schematic design workshop #5

University of Oregon, Student Recreation Center

January 16-19, 2012

**Project User Group (PUG) Meeting 5A – 1/17/12****Schematic Design**

East Elevation Option 1

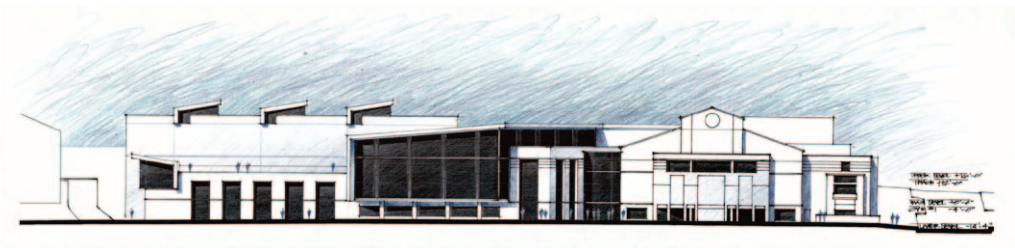
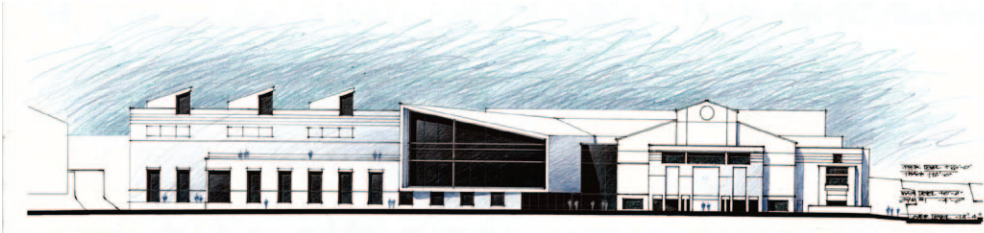
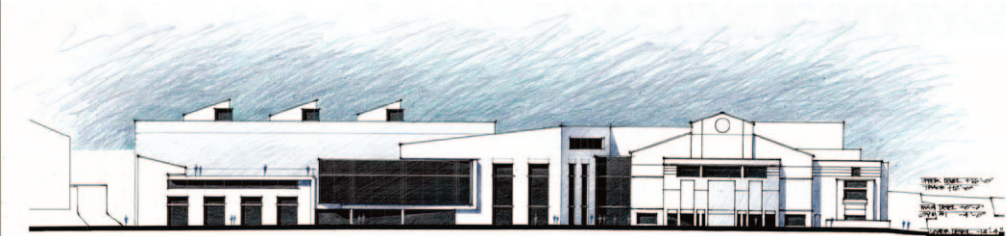
16. User Group finds Option 2 a little jarring and competes too much with the existing east gable end. It also does not help define the east entry.
17. Options 1 and 3 build on the elements on the north edge of the '99 SRC.

18. Secondary entry is not yet articulated enough. Consider the depth of the entry with regard to being able to find it. Consider what markers or horizontal cues (paving) that maybe incorporated.

19. The cantilever extends quite far to the east. There needs to be a sense that it will not fall off the face of the building.
20. The monitors on the gym could come out to the building edge or be held back. There were differing opinions among the user group. Wind power ventilators are a possibility for the gym or other roofs.
21. The User Group prefers Option 1 and to a lesser extent Option 3. Option 1 glazing works better with the existing '99 SRC. The design is contemporary and meets the sky well. Eliminate option #2. Use of materials will impact how everyone feels about the design.

- Better define the east entry; the proposed deep recess is not adequate.
- Ensure that the east façade fits into the fabric of the campus's design and function. As designed, the proposed shape is not found on campus. Use the existing 15th Avenue façade as an example of how the design should connect to the broader campus and Esslinger Hall through the use of materials, a main entry, façade definition, and roof shape.

- Reassess the design and function of the east façade's angled cantilever over the pathway. As designed, it does not seem to relate to the fabric of campus, and it only partially covers the proposed seating area. Recognize the range of important functions the covered space serves and determine how best to address the key functions (consider moving bike parking out of this area).
